## Proposed Mixed-Use Development Known as Liverpool Civic Place – 52 Scott Street, Liverpool

TfNSW Reference: SYD19/00516/11

Council Reference: DA-836/2020

This letter has been prepared to address the matters raised in the letter from TfNSW dated 4<sup>th</sup> December 2020 and Council's internal assessment in relation to the subject development application. We have maintained the comment numbering for ease of reference, noting that some of the points raised relate to road improvements proposed by Council outside the scope of the subject DA.

St Marys Cathedral car park

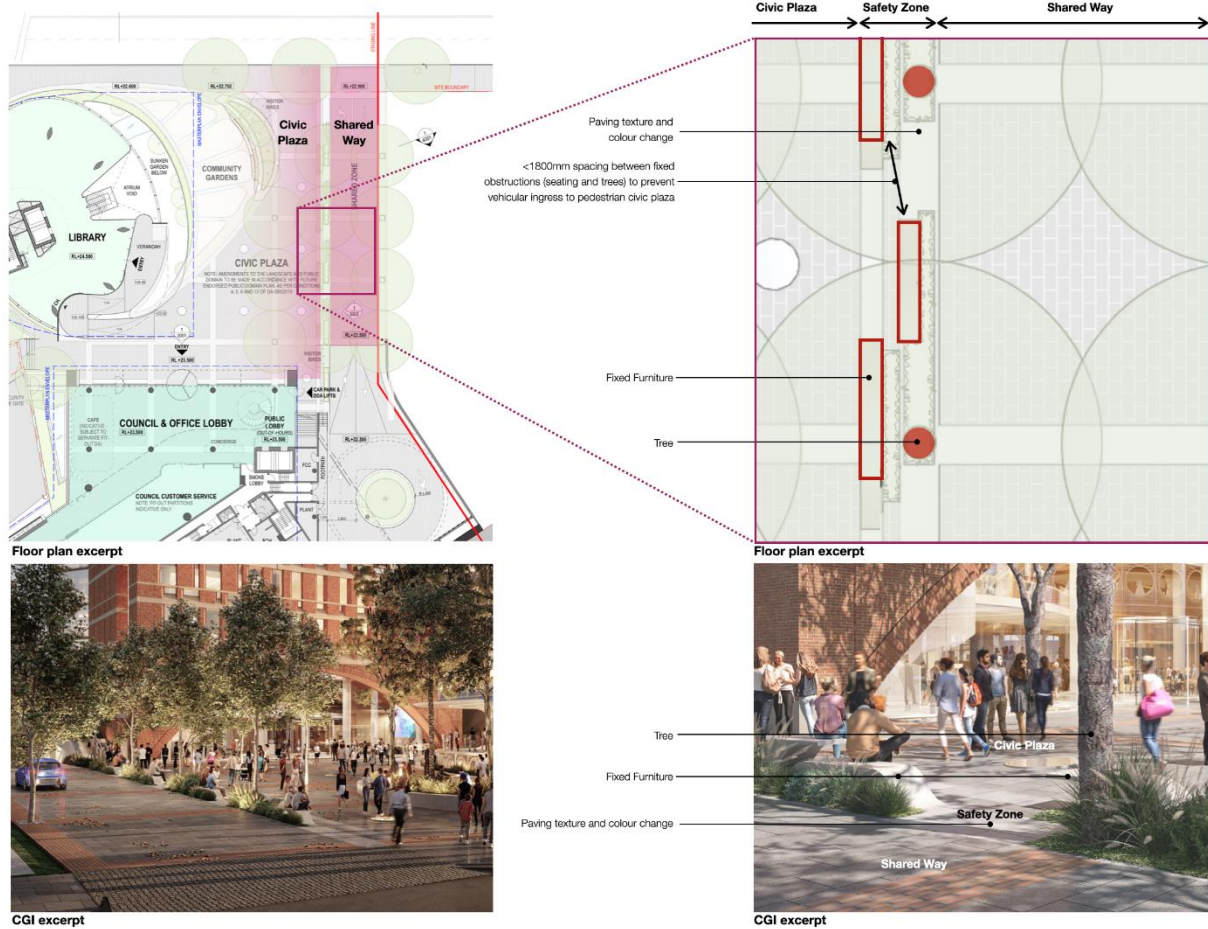
*The Panel notes that there will be potential conflicts with pedestrians and cars entering the shared way. The Panel recommends the applicant to consider appropriate measures to ensure that future conflicts are reduced. The Panel recommends Council to review the traffic arrangements thoroughly at the approval stage to ensure there are no conflicts; and a traffic management plan is implemented.*

*The Panel notes that CPTED principles are being considered however recommends the applicant to consider appropriate tree specifications to ensure ground level visibility.*

The shared zone proposed has been adopted as a means of prioritising pedestrian movement across the plaza in line with the objectives of the Technical Direction. Other examples that have been referenced in the design of the shared zone include, St Marys Cathedral car park, The Crescent, Mosman, St Margarets in Surry Hills, Mount Street in North Sydney and Circular Quay (east).

The shared zone will be supported by the required signage, and safety provisions such as the high contrast edge-lines designed into the plaza landscaping design, the trees and seating to prevent errant vehicles accessing the plaza etc. This will be subject to detailed design during the CC stage of the project.

Public domain plan includes physical items that prevent a vehicle travelling from the shared zone to the plaza (maximum gap of 1800mm to prevent vehicles pass between the physical objects).
